Access Compliance Report

Public Rights-of-Way

(Pedestrian Signals)

Intersection ID: N/A	Main Street:	Cross Street: N/A	Location: N/A
ADA ID: C59BE2643485	Signal Type: One Push Button-Non APS	Overall Compliance: No	Severity Score: BTN 1: N/A BTN 2: N/A No BTN: N/A
Codes/Mitigation Info/Possible Solution		Field Measurements/Component Compliance

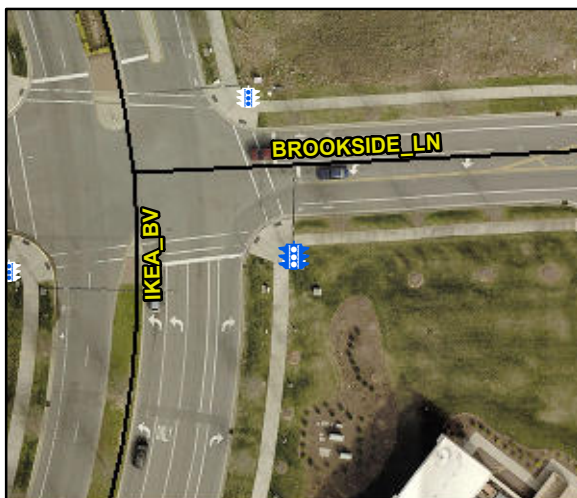
Surveyor Notes: TEXT HT 7/16

PROW/ADA: R410.6, TMUTCD 4e.08, R404.2, R404.3, R406.2, R404.7.3

Possible Solutions: Replace Signal Push Button With APS Button on New Post. Remove & Replace Sign.
